Replacement of T9 Pump

The previous pump **(TL-B11-220012)** used in the T9 from Insatech has been discontinued. Going forward a new pump **(TL-B10-A12-0905-W-07150)** is replacing it.

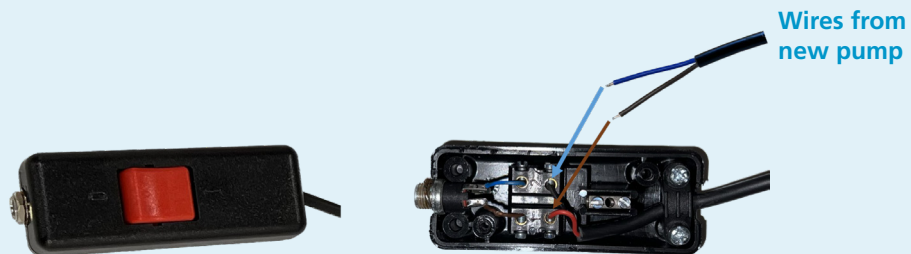
1× Custom adapter – To handle the smaller inlet tube on the new pump an adapter has to be placed in the original pump fixture as seen below.
Part no.: 10372-3503-P2074, Length: 25 mm, Diameter: 33.2 mm, Hole diameter: 18 mm.

1× Silicone hose – The outlet tube of the new pump is located further way.
Part no.: 228-1524, Length: 220 mm, Diameter: 16 mm, Hole diameter: 10 mm.

The on/off switch can be reused by removing the wires from the old pump and connecting the wires from the new pump. For safety reasons please disconnect the power supply.
